RE: JMC Project 13021
Route 17K VW Dealership
Route 17K
Town of Newburgh, NY

Conceptual Approval

We are pleased to submit the following drawings and documents for the continuation of review of the Volkswagen of Newburgh project located on Route 17K:

SITE UTILITIES PLAN
VOLKSWAGEN OF NEWBURGH
ROUTE 17K VW DEALERSHIP
TOWN OF NEWBURGH, NEW YORK
SP-5

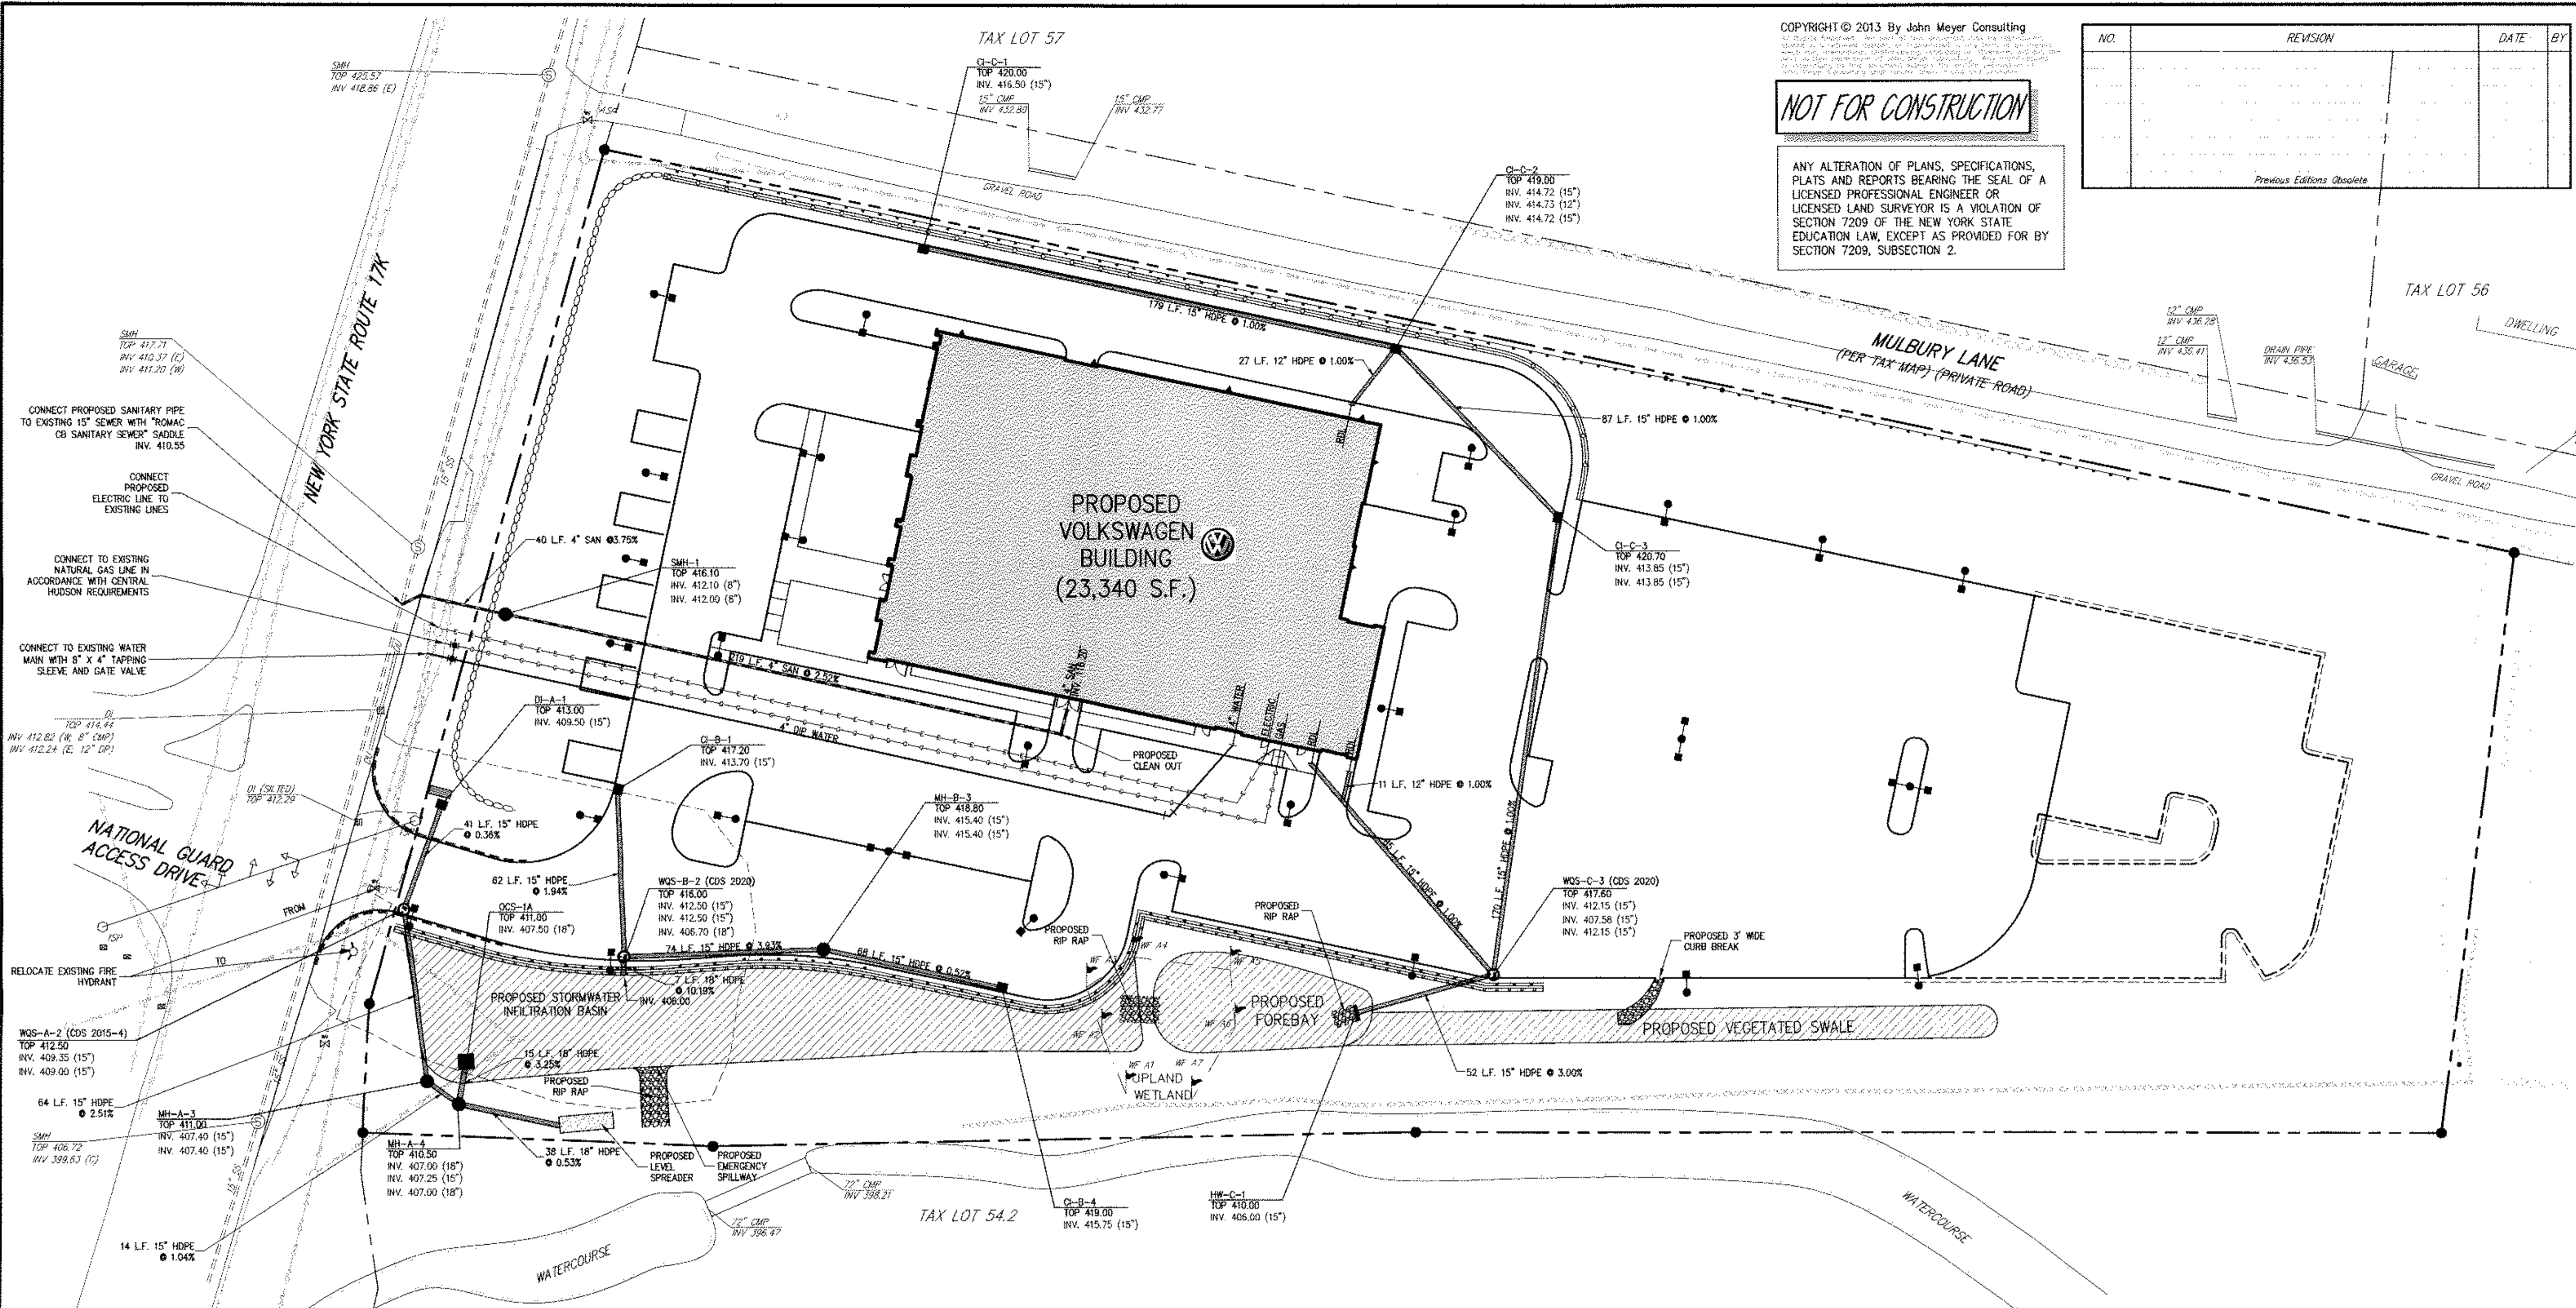
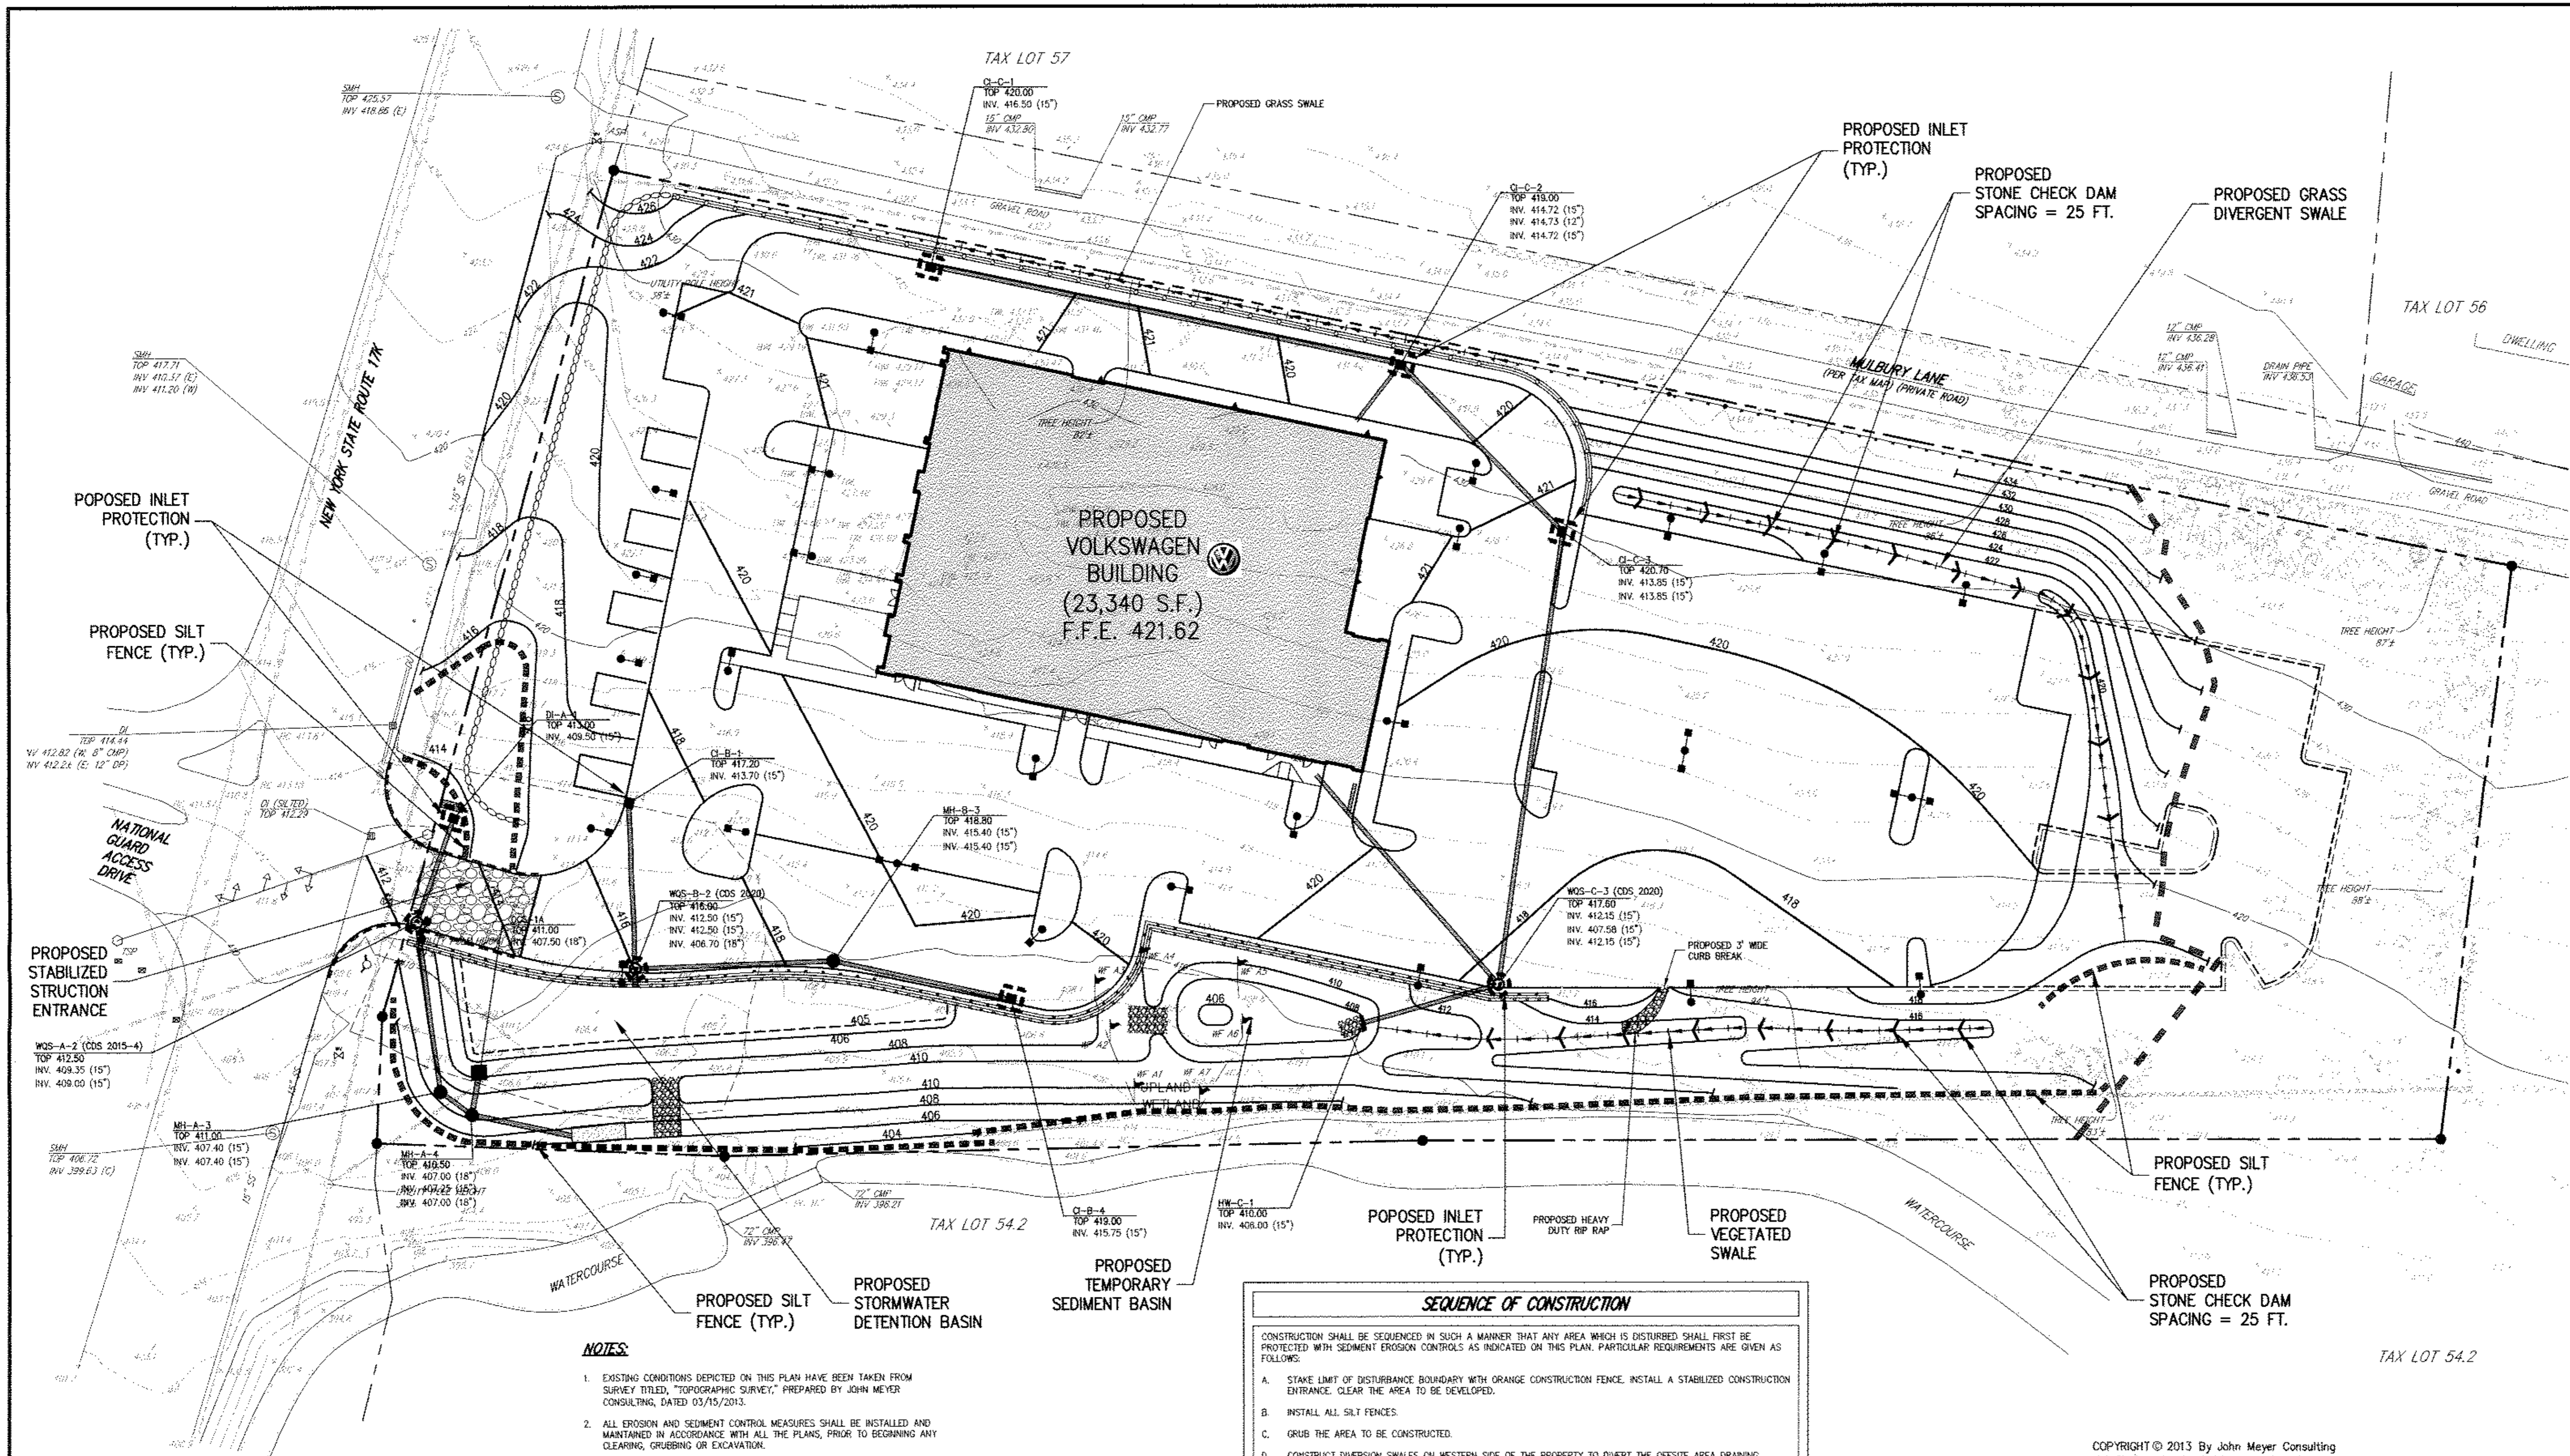
Comment No. 2

Utility connections to the existing utility services have been illustrated on Drawing SP-5 "Utilities Plan".

DRAWN: MTP APPROVED: RR
 SCALE: 1" = 20'
 DATE: 11/07/2013
 PROJECT NO: 13021
 DRAWING NO: SP-17

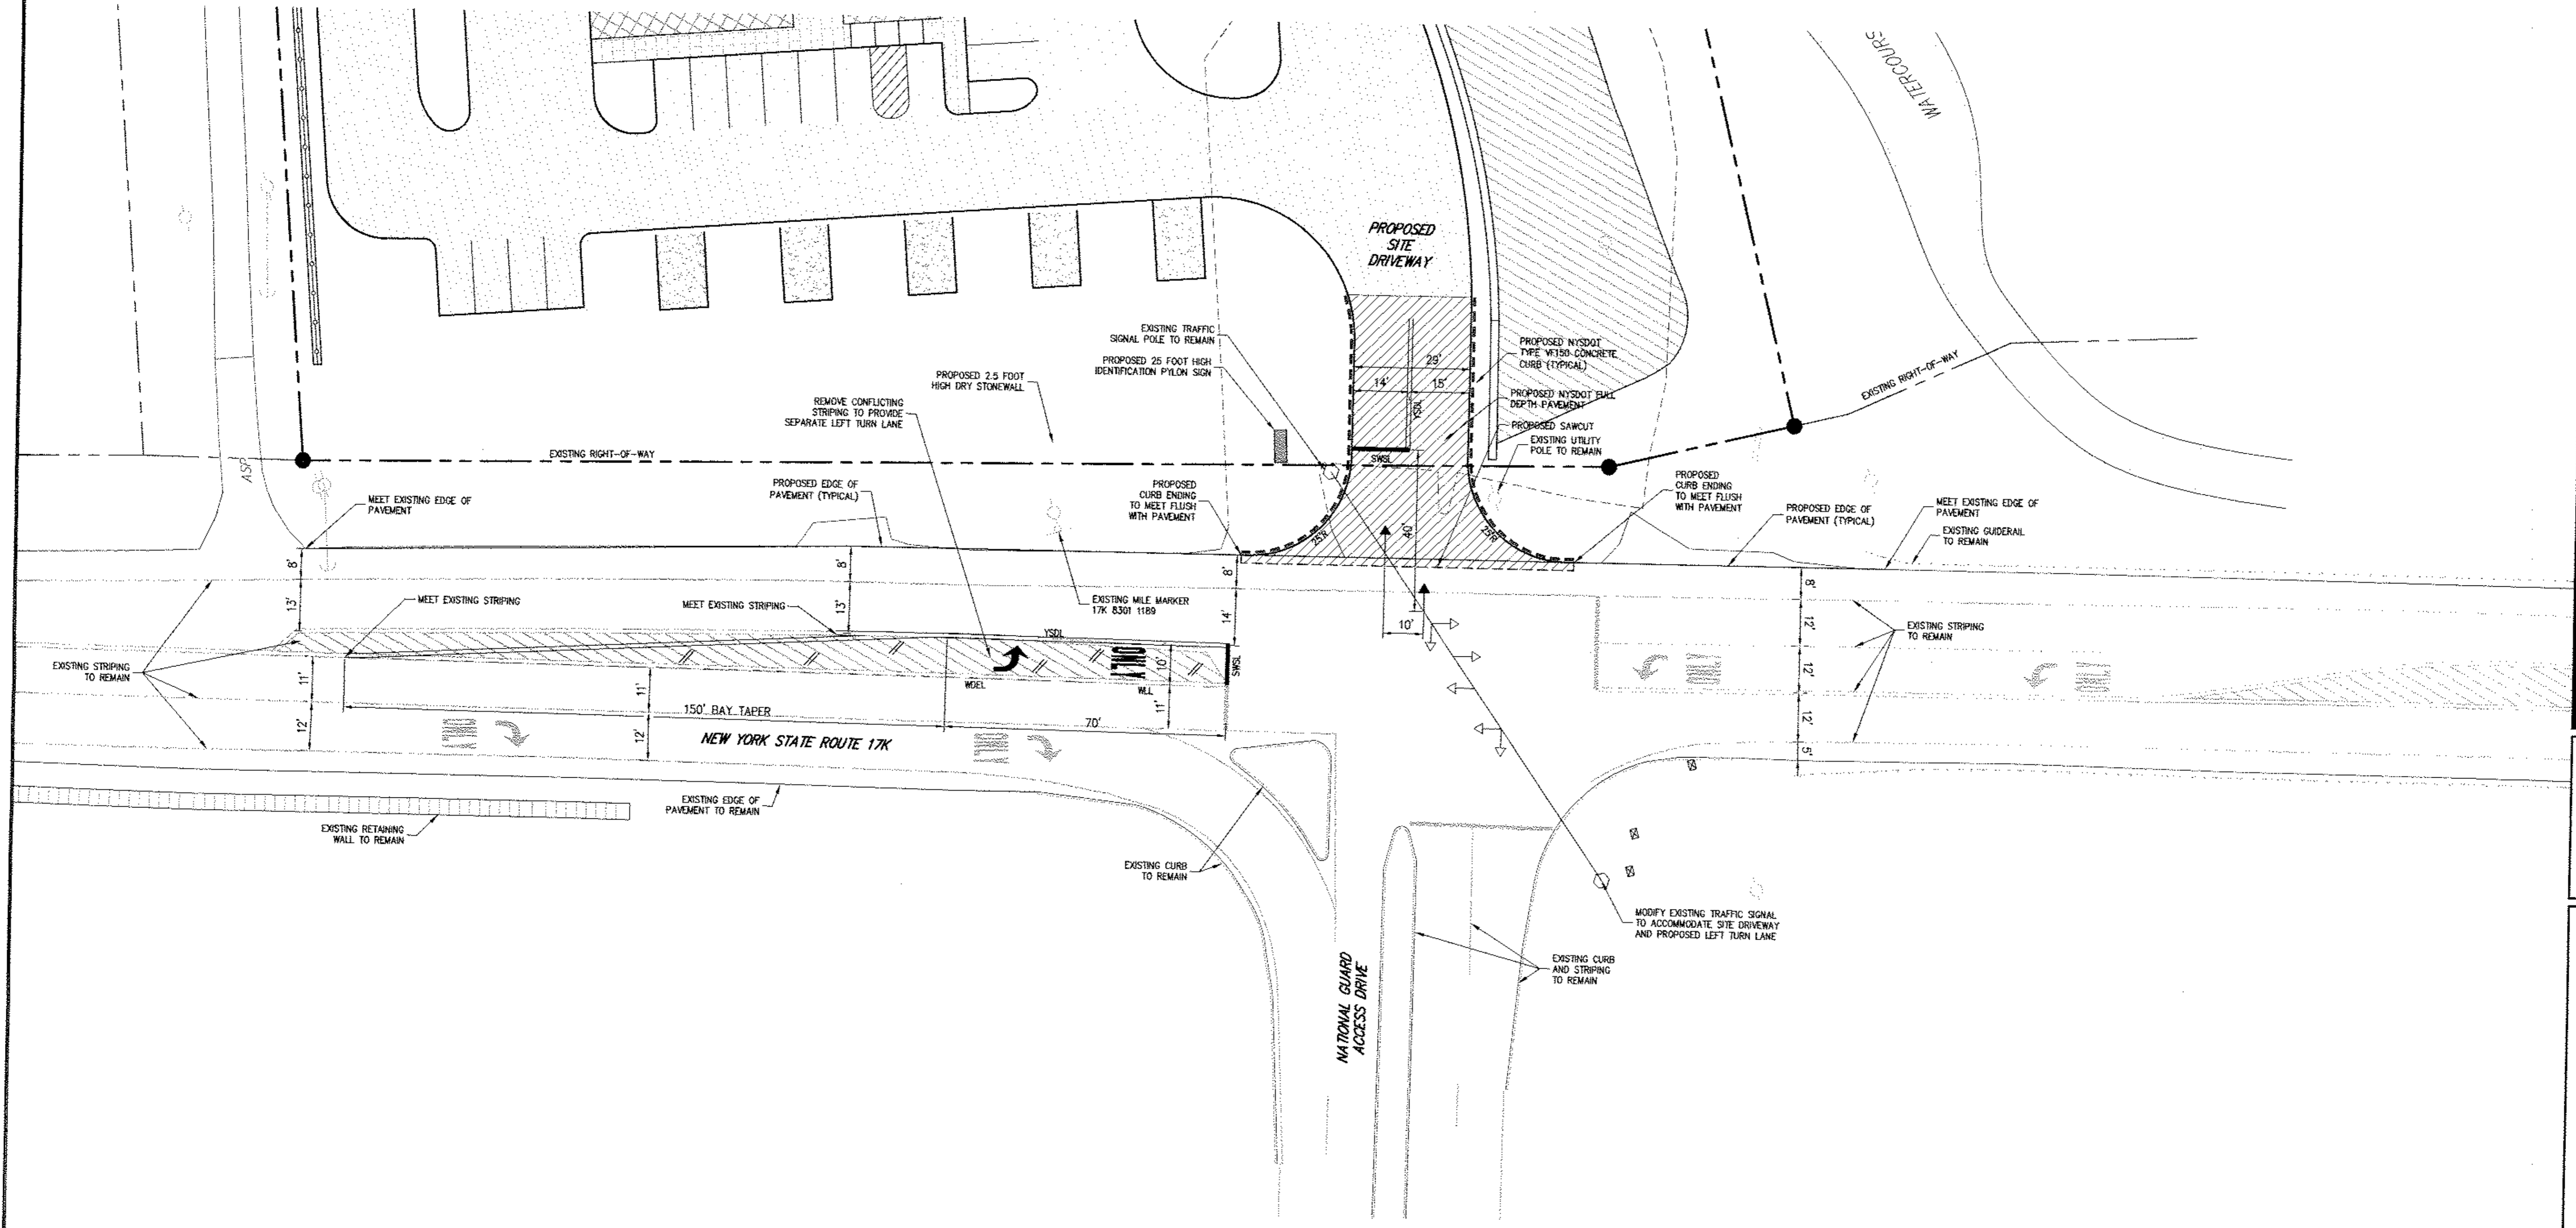
Comment No. 2

Show the truck circulation route for inventory deliveries.

Truck turning analysis has been included in the submission as noted on Drawing TA-1 "Truck Turning Analysis Plan".
